**SUBJECT: Revised Final Characterization Report
Small Arms Range Airfield Parcel (SEAD-122B)
Seneca Army Depot Activity
Romulus, New York**

**CHARACTERIZATION REPORT FOR THE SENECA
ARMY DEPOT ACTIVITY
SMALL ARMS RANGE
AIRFIELD PARCEL (SEAD-122B)**

RESPONSE TO COMMENTS

Response to Comments from the New York State Department of Environmental Conservation

FIGURE 3.2

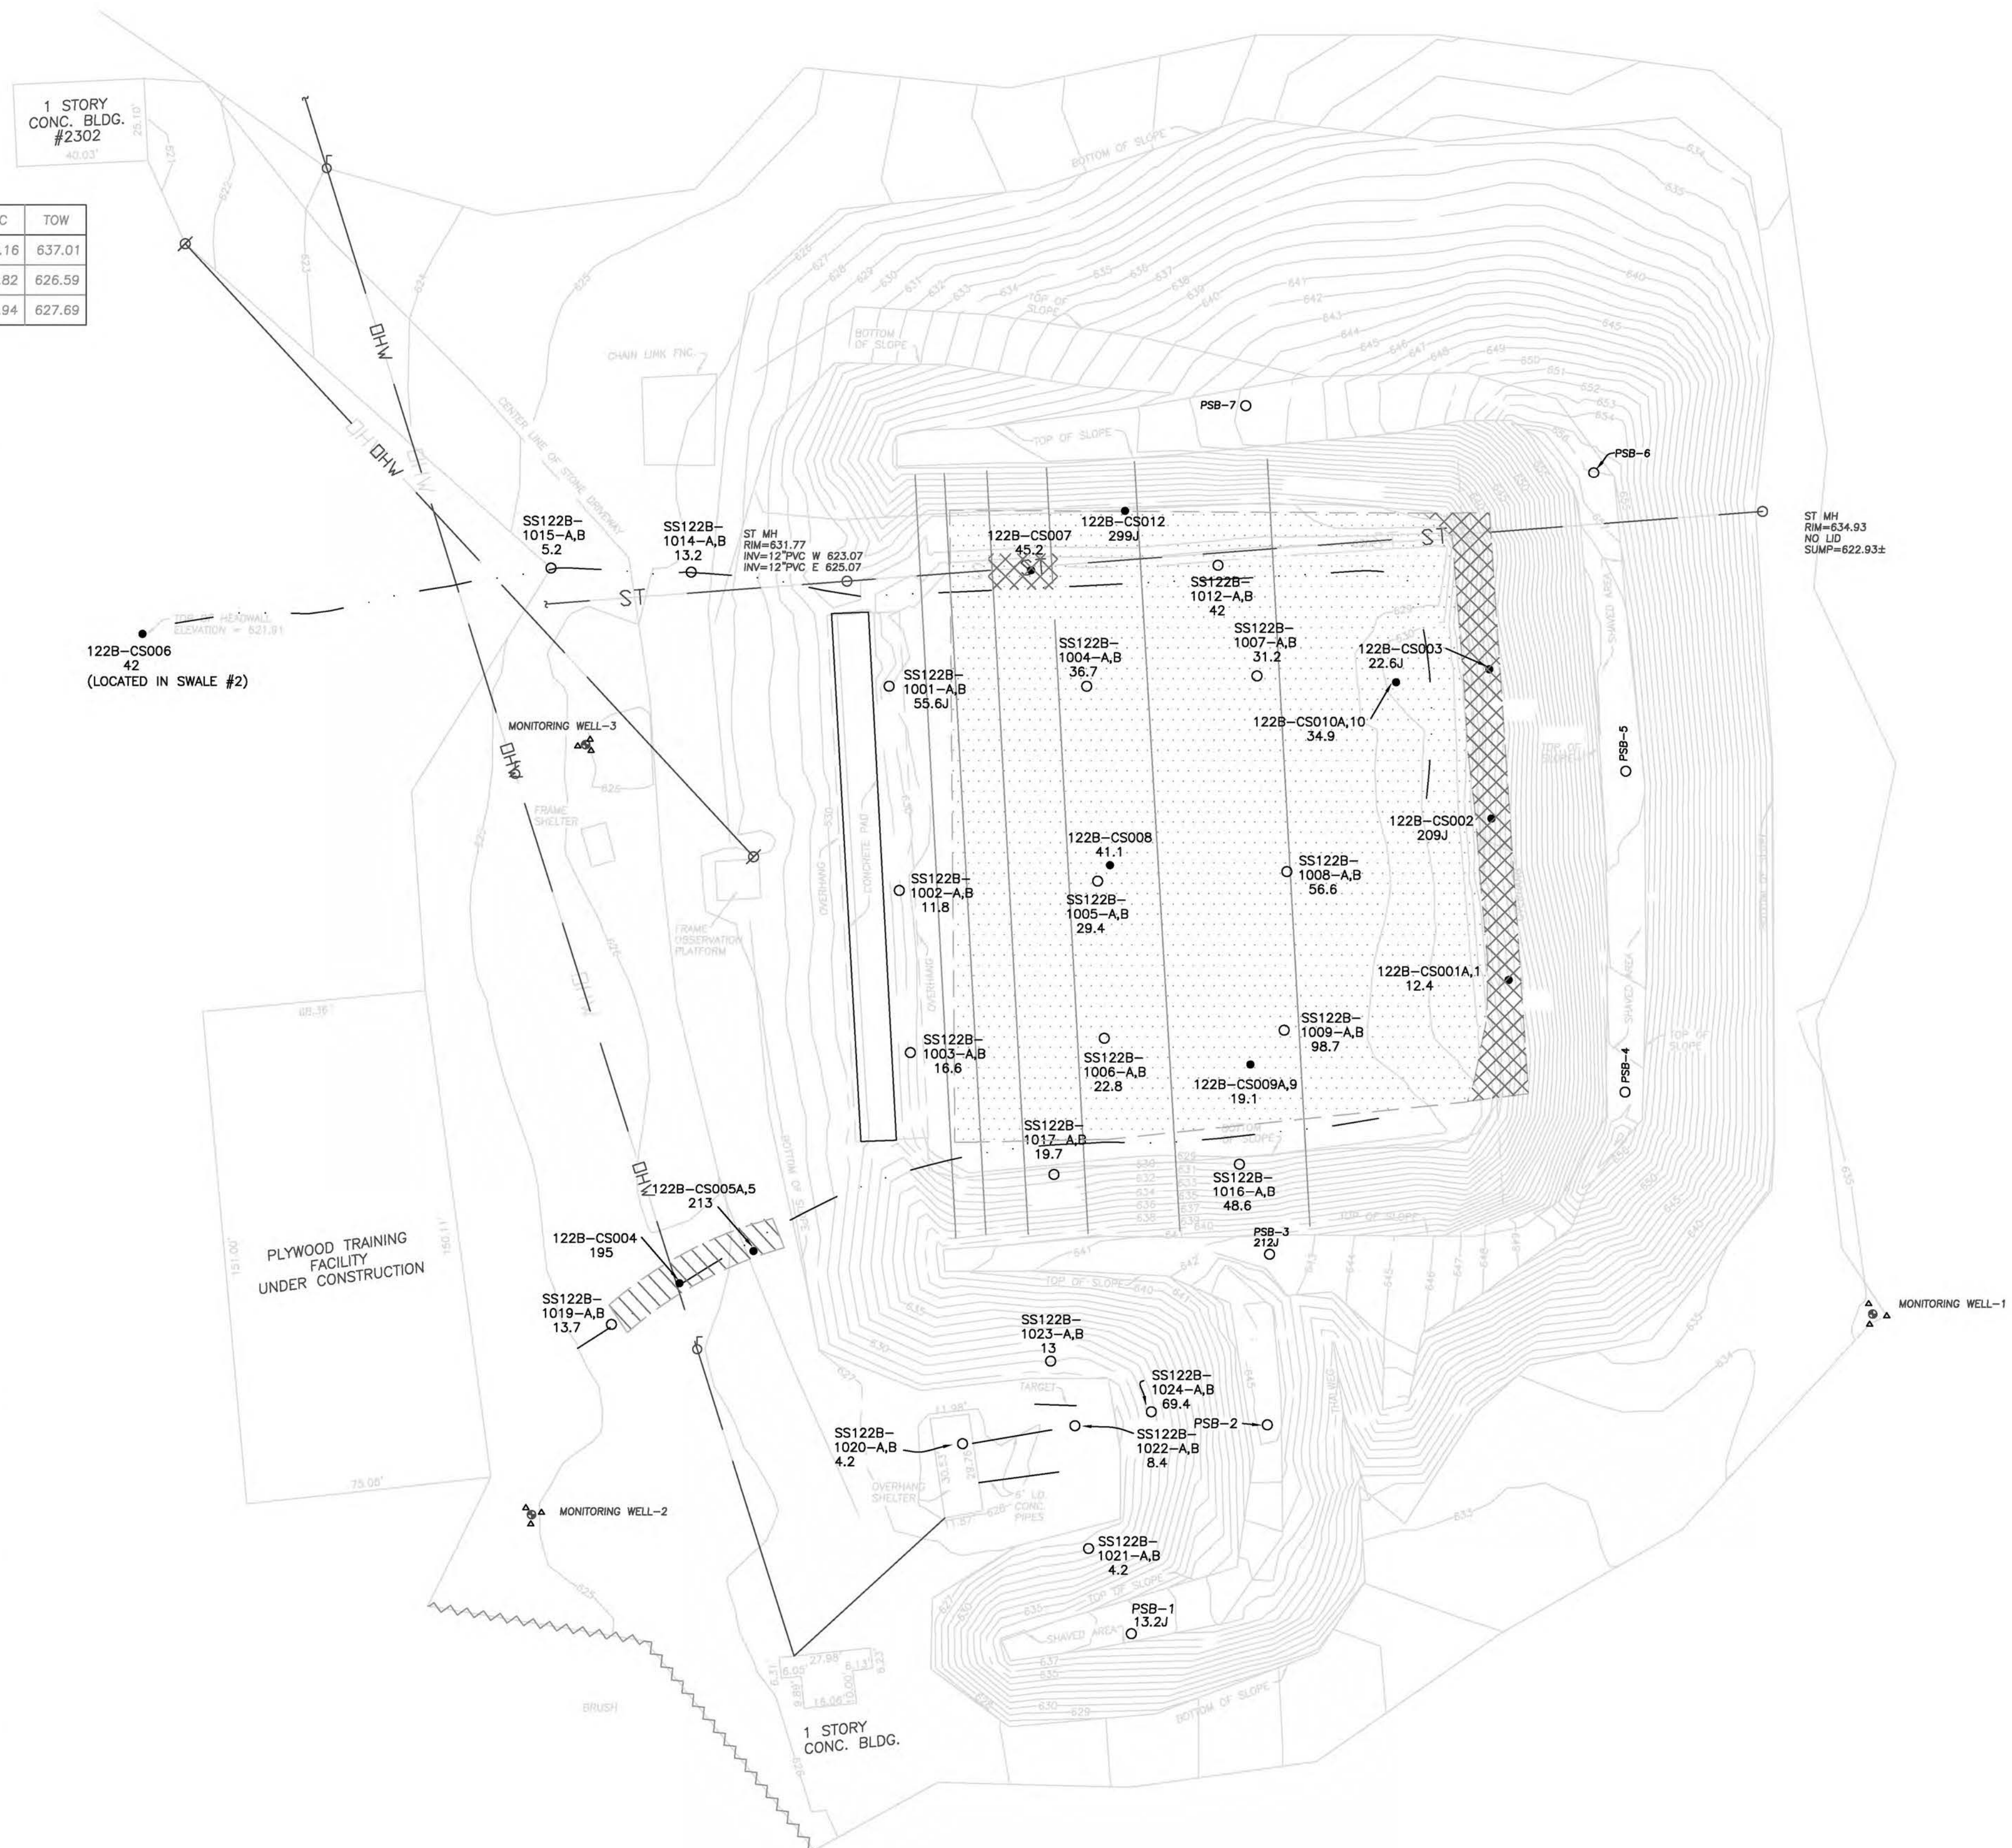
Comment 1: The final verification samples collected at the site (Figure 3.2 and Tables 3.7) appear to be the same as those contained in the Treatability Study (FINAL CONFIRMATION SAMPLES, TOTAL LEAD, Table3), however the values are not the same in all cases. It appears that a few numbers may have been transposed in producing the Treatability Study Report and they need to be corrected.

Response 1: Agreed. Table 3 will be corrected to reflect the results as stated in Table 3.7 of the Final Characterization Report.
